**LEGISLATIVE COUNCIL
PANEL ON PLANNING, LANDS AND WORKS**

Proposals for Preservation of Queen's Pier in Central

Attachment A – Views on Proposals for Preservation of Queen’s Pier

Planned Infrastructure

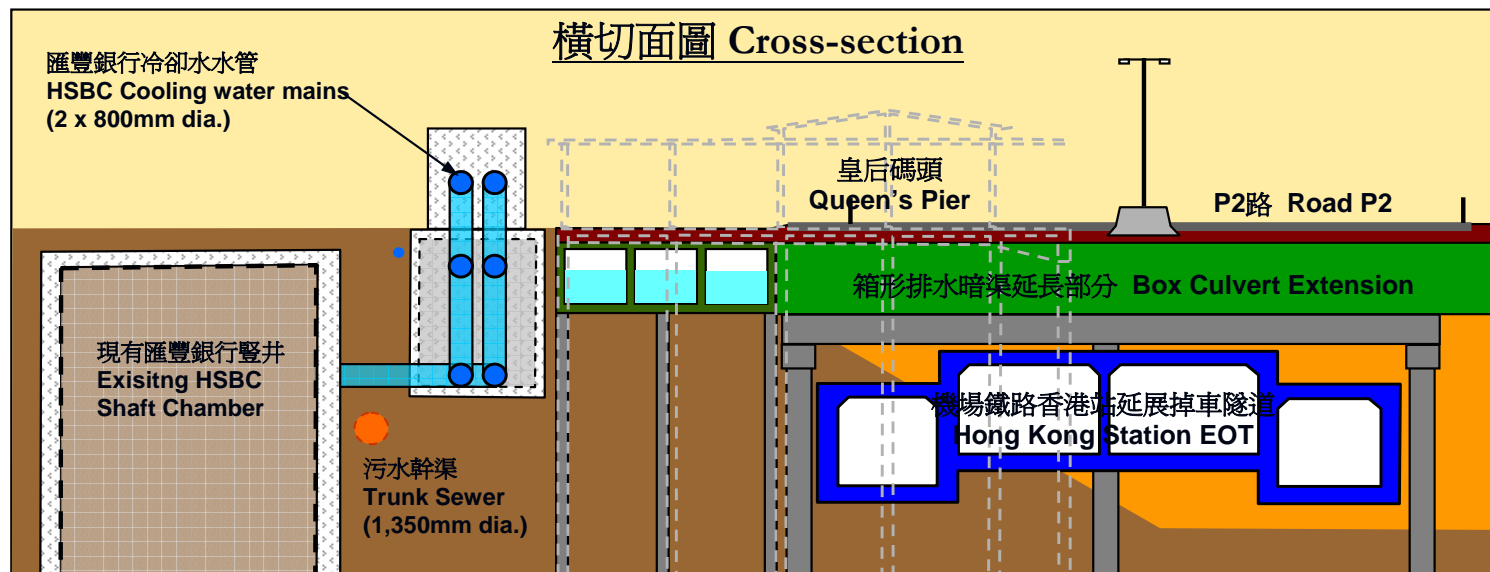
7. In our discussions with the professional bodies, we have explained that the planned infrastructure works which directly affect the Queen's Pier include the AR EOT, the extension of an existing drainage box culvert at Man Yiu Street and the Road P2 (as illustrated in **Attachment B**). The difficulties in relation to the modification of these works now to avoid the Queen's Pier are set out below :

- (c) The existing stormwater drainage box culvert located at the waterfront of Man Yiu Street is the main strategic stormwater discharge route for Central. It has a catchment area of 73 hectares covering the core business areas of Central as well as the Peak area. Due to the reclamation under the CRIII, the stormwater drainage culvert has to be extended to the new waterfront to continue its operation. As the level of the culvert clashes with that of the EOT mentioned in (a) above, the culvert cannot be extended northwards along Man Yiu Street and has to run eastwards along the southern side of the EOT. Moreover, the extent of realigning the culvert to the south is constrained by the presence of General Post Office and Hongkong Land's cooling water mains to the west of Edinburgh Place and the Hong Kong Bank's cooling water mains and a 1350 mm diameter trunk sewer outside the Queen's Pier. The culvert will therefore conflict with the Queen's Pier. Apart from the horizontal alignment, the culvert at the concerned section is very shallow with the top level at about +3.0m PD and will thus conflict with the ground beams as well as the piled foundation of the Queen's Pier.

In order to eliminate the conflict with the Queen's Pier, a S-curve will need to be introduced in the current alignment of the culvert. As the fall of the culvert is very gentle, i.e. about 0.05% due to the topographical constraints, such a change in alignment will affect the hydraulic performance of the culvert.

重新組裝皇后碼頭的可行位置 Possible Location for Reassembling of Queen's Pier

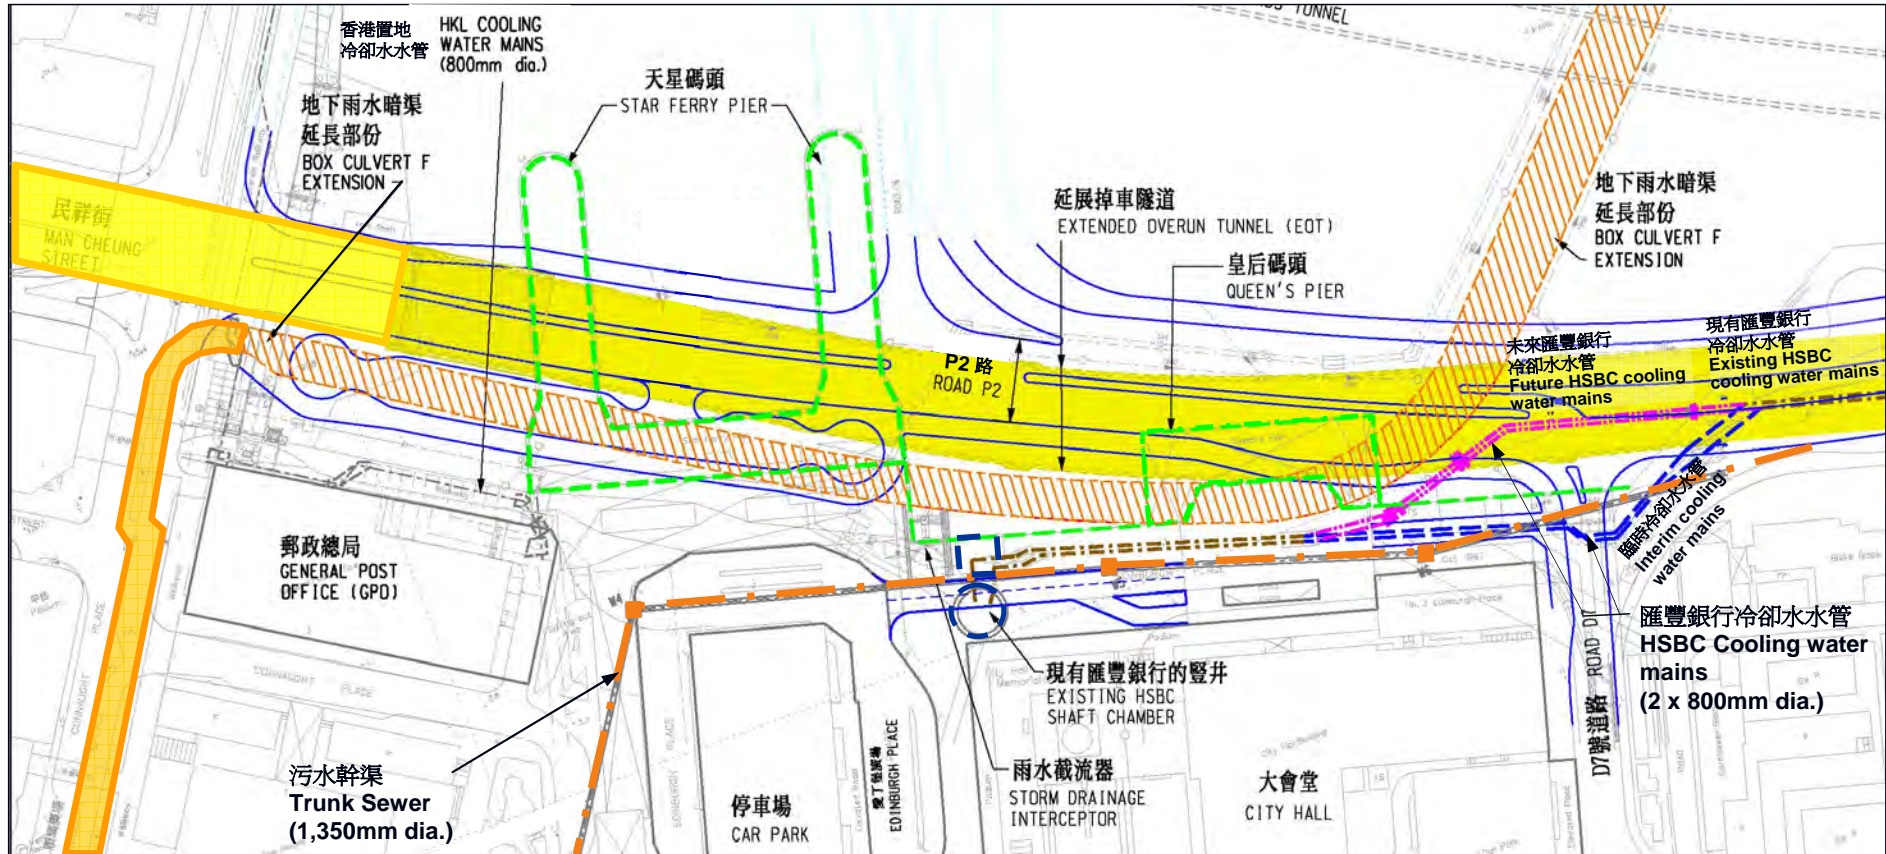
example, there should be sufficient space for the reassembling of the Queen's Pier just to the west of its current location opposite the City Hall complex (as indicated in **Attachment C**). The professional bodies have suggested that landscaping and urban design enhancement be made to the open space formed by the reassembled Pier and the City Hall complex, complemented by adequate pedestrian provisions. This suggestion would be followed up in the Central Reclamation Urban Design Study.
